S E R V I C E N O T E

16380C Standard Capacitor Set

Modification prevents potential damage to the carrying case

Figure 1.

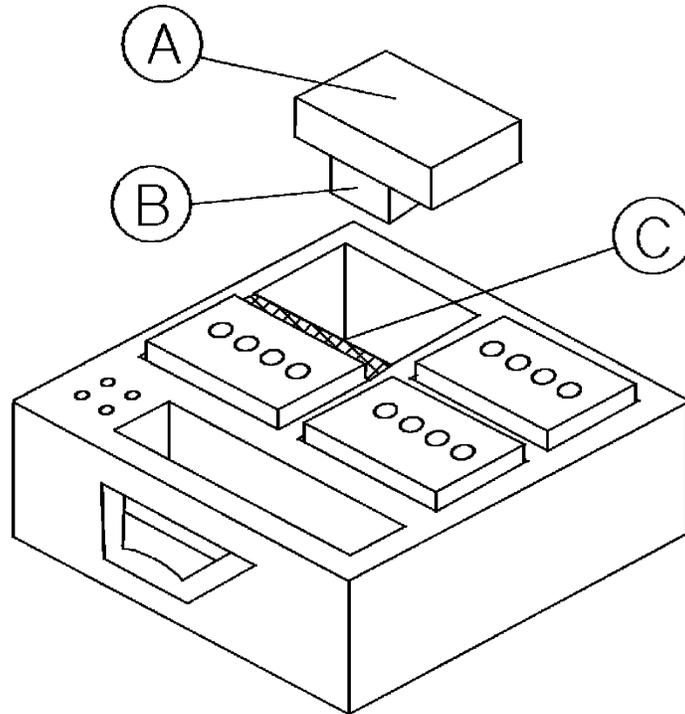
It is possible that a number of 16380C Standard Capacitor Set have been shipped with missing a plastic (foamed urethane) part in a vacant space of the carrying case (See Figure 1, part B). The plastic part is invisible from outside, but this may cause mechanical damage to the standard capacitor.

Check the carrying case by pushing down part A in Figure 1 with your finger. If part A sinks, replace the block with the new one (P/N 16380-89201).

If the partition of the carrying case (part C) is broken, replace the whole carrying case with the new one (P/N 16380-85104)
